PERMIT

SEWAGE DISPOSAL SYSTEM

MARYLAND STATE DEPARTMENT OF HEALTH

SUBDIVISION Shepherds Glen

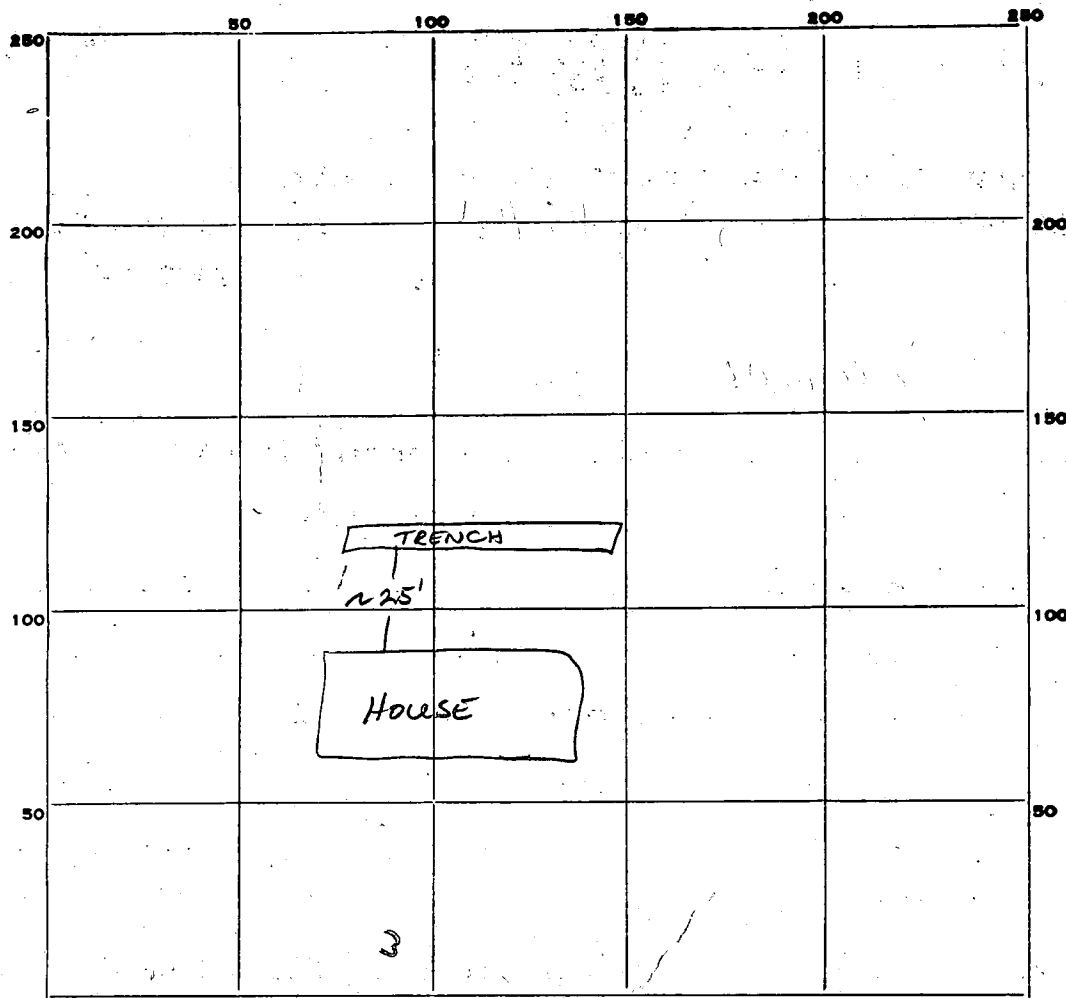
Trench 62' between ST & DB, run parallel to house from left corner as seen from Walt-Ann Dr., depths same as in option #1 of order TSO

REMARKS 12/13/77 T.S.D. Trench OK to add stone & pipe
12/15/77 T.S.D. Stone & pipe OK - Finish covering pipe w/ stone, cover
w/ building paper & call for final
12/16/77 Stone and heavy bldg paper installed. OK to cover WWZ
